RE: Request to Approve Change Order #02 –
BMS Furring Out Walls **DC**
Bernheim Middle School Renovation

Change Order

REQUEST FOR PROPOSAL

INTEGRATED BID SET - CONSTRUCTION DOCUMENTS
 FURRED-OUT WALL LOCATIONS
 BERNHEIM MIDDLE SCHOOL RENOVATION
 SCA 23-051
 DATE: 08/15/22
 DRAWN BY: SCS
 CHECKED BY: SCS
 REVISIONS:
 2022-36
 RFP-1

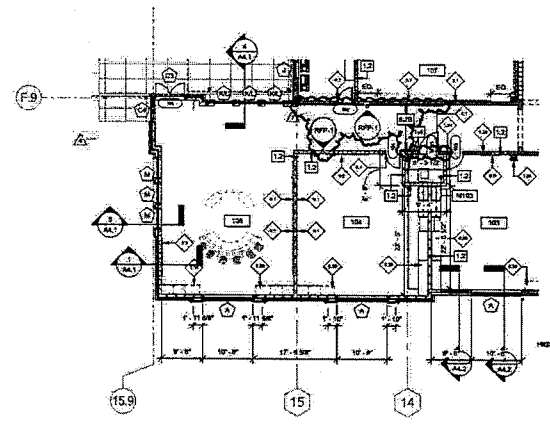
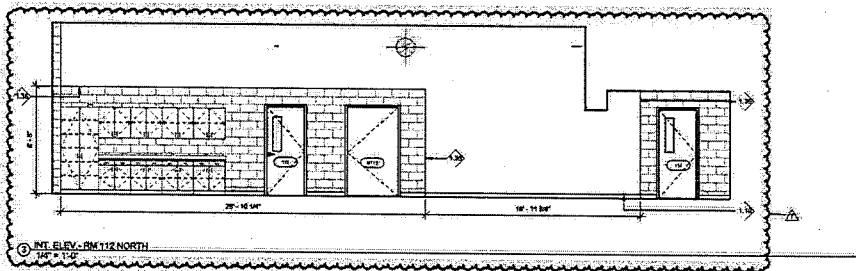
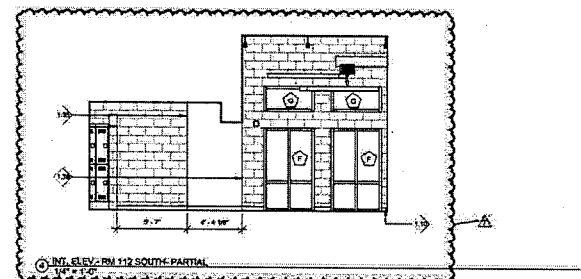
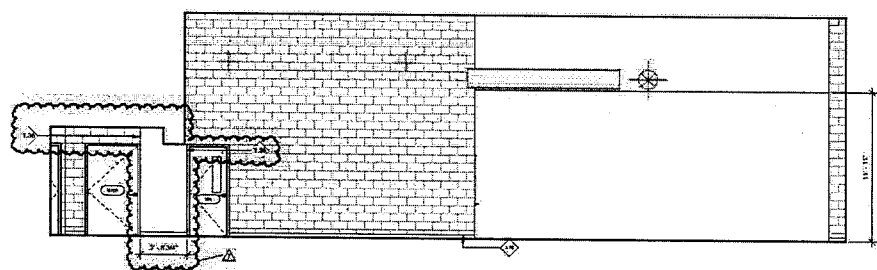
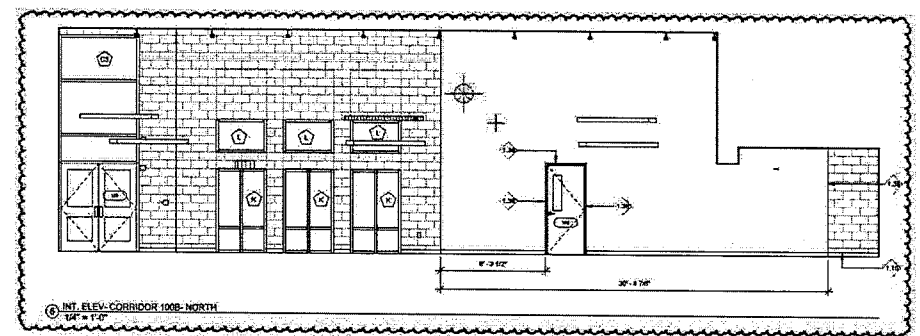
- Item 1:** REFERENCE Revised drawing A0.1 and RFP-1
- Added new furred out walls along existing CMU walls as noted in bubbled areas. Walls are either 3 5/8" or 2 1/2" stud as noted on revised sheet A0.1

When brick veneer was removed from the exterior walls, damp proofing from present of the face of the existing CMU block. This material cannot be removed entirely and would not yield an acceptable finish if it was. It is recommended by the Design team that walls with damp proofing be covered with gypsum board and framing to yield an acceptable wall finish.
